ADDENDUM NO. 1

**Administration Building Renovation Re-bid
Compton Community College District**

tBP Project. No. 20987.00

tBP/ARCHITECTURE

ROOF/CANOPY CONDUIT AND PULL BOX INSTALLATION SCALE: NONE 2

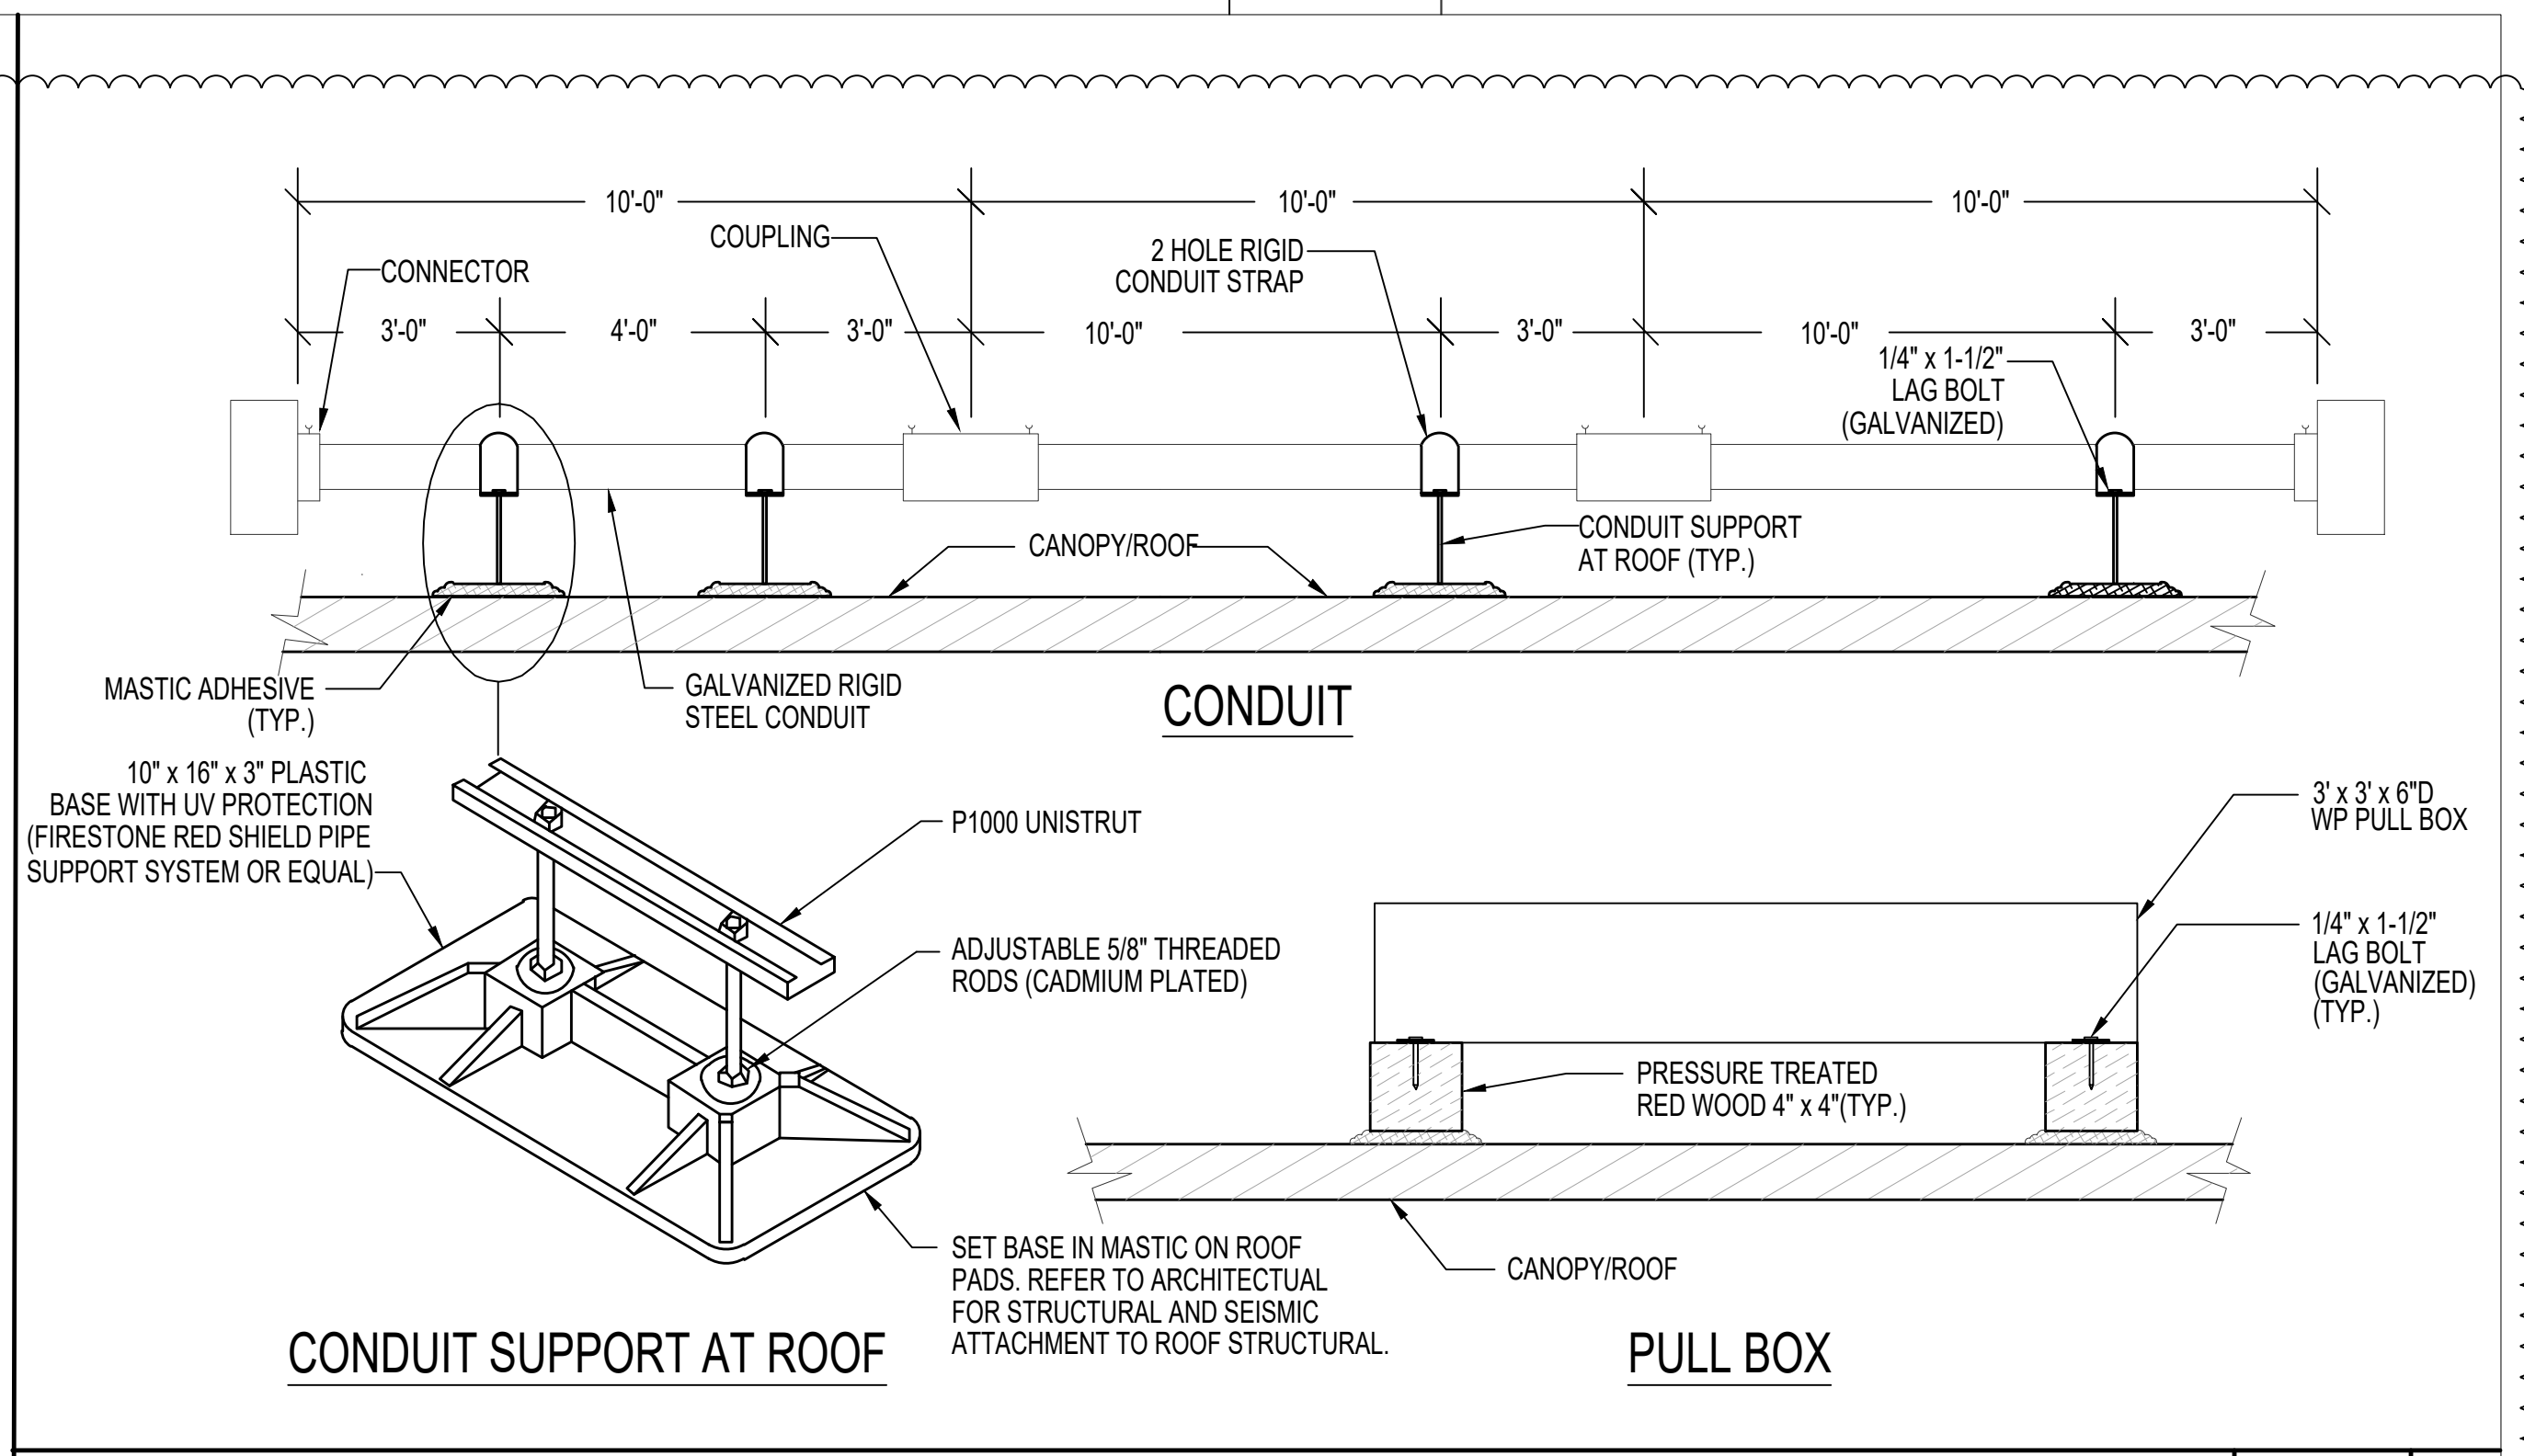
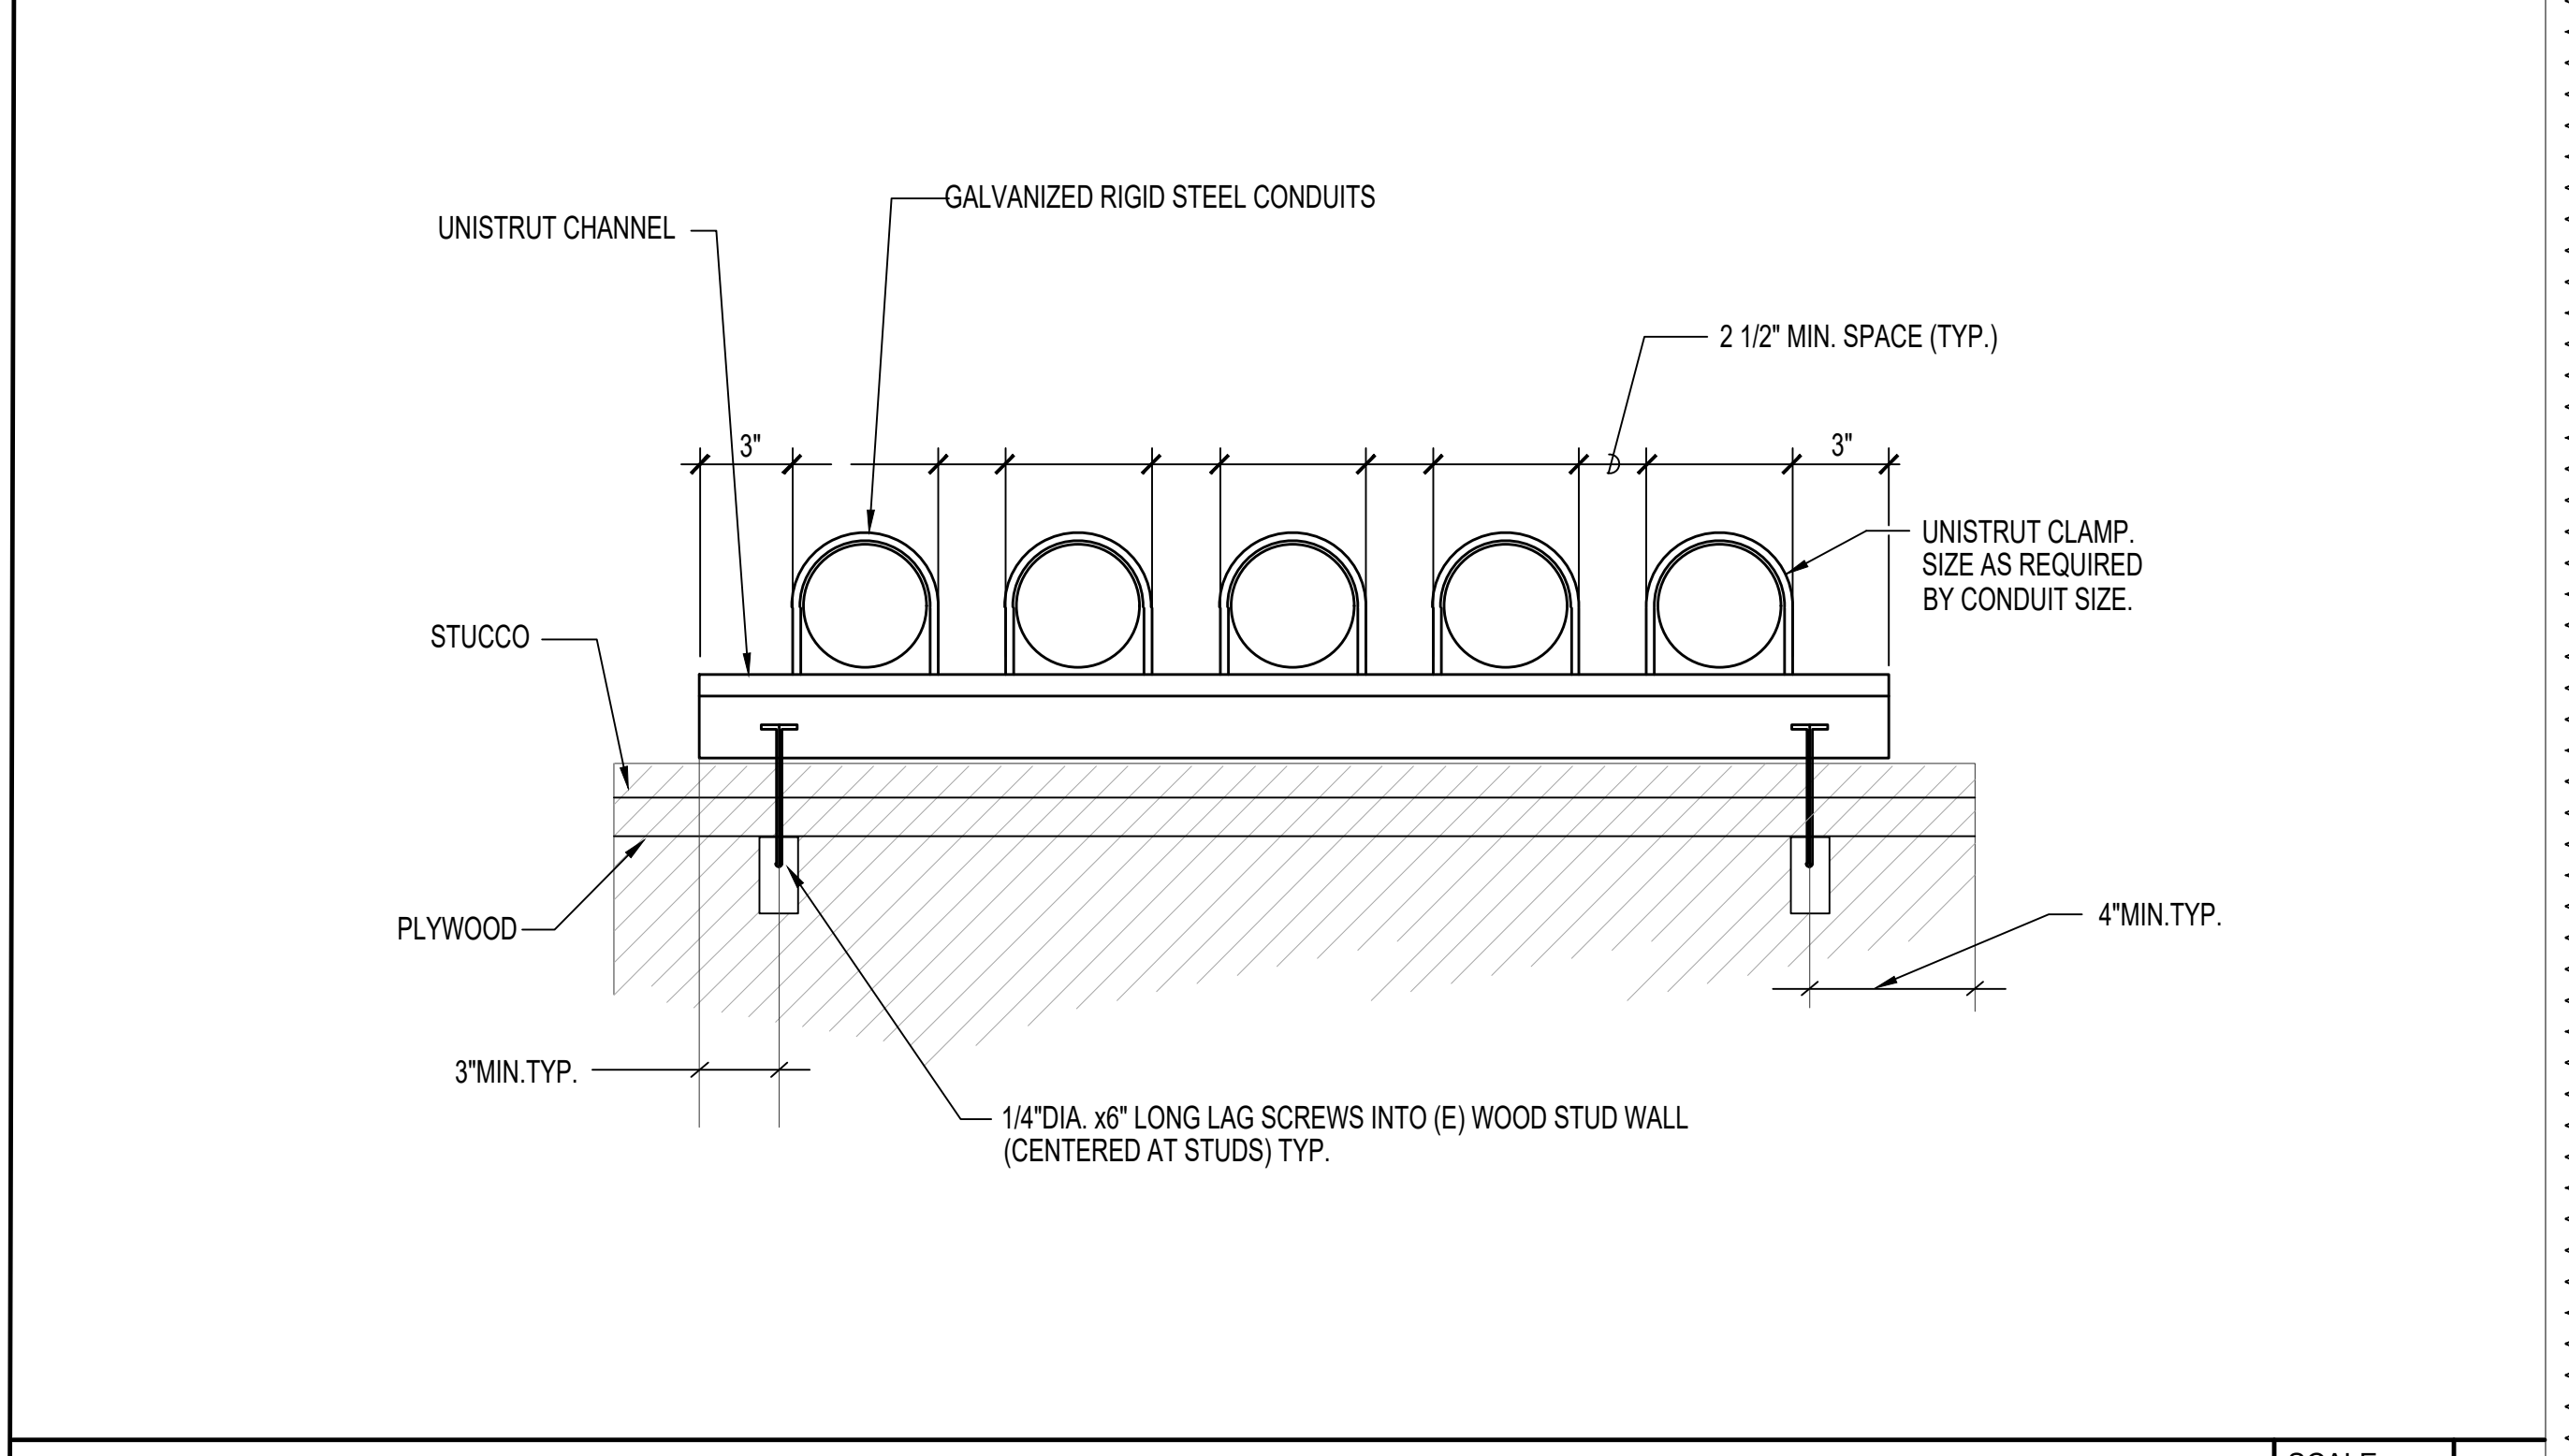
31. Revised Sheet E2-2 Roof Electrical Plan

- a. Updated Roof Plan based on revised Mechanical Plan.
- b. Indicated power feed from electrical room to new ADMP panel located on the roof.
- c. Added Details 2 and 3 for roof/canopy/mounted conduit and pull box.
- d. Revised Plan Notes.
